**GREATER HARTFORD TRANSIT DISTRICT
GHTD IFB #11-020
PUBLIC RESTROOM EXPANSION AND RENOVATION (UNION STATION)**

ADDENDUM #2

June 23, 2020

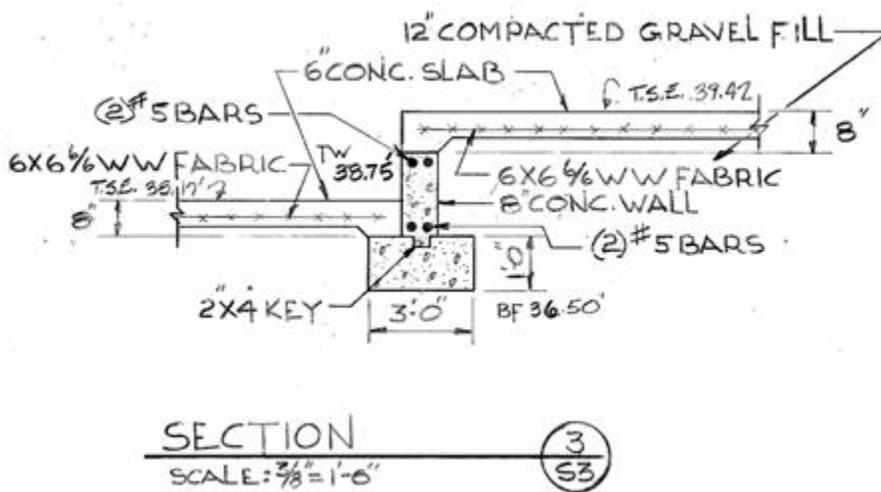
18.) Question: Please provide the thickness of the slab at the Restroom/Locker rooms.

Answer: To be verified in field, the 1985 detail is shown below.

Answer: Cannot be determined at this time without probing. There are no 'as-built' drawings. The 1985 drawings show concrete slab, 1" thick bedding, 1.5" thick Stone Flooring, and there must be Grout and Floor tile on top.
